22111-03-005

PROPOSED RESIDENTIAL DEVELOPMENT, MAYESTON S179A, POPPINTREE, DUBLIN 11

ROAD SAFETY AUDIT STAGE 1/2

Figure 2.2 No pedestrian crossing facilities shown

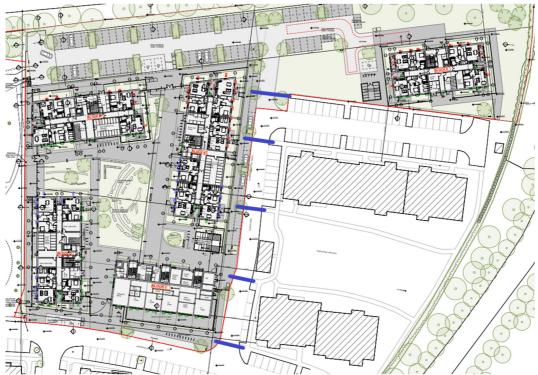
This site is on the opposite side of the road to existing developments (Mayeston Green and Mayeston Downs). This is likely to generate trips by vulnerable road users across the existing roads.

However, there appears to be no dedicated pedestrian crossing facilities with dropped kerbs and tactile paving shown on the drawings to cater for vulnerable road users.

Residents wishing to access the creche or cross to the buildings on the east will have to walk through dedicated car parking with no pedestrian facilities shown on the drawings.

There is also no crossing facility provided at the junction of Mayeston Green with Mayeston Downs.

This could lead to risk taking by vulnerable road users, problems for wheelchair users, and potential collisions with vehicles leading to injuries.

Ensure that tactile paving and dropped kerbs are provided at all footpath/cycleway crossing points throughout the development and ensure that continuity of footpaths is preserved so that residents do not have to walk through parked cars to cross the roadways.
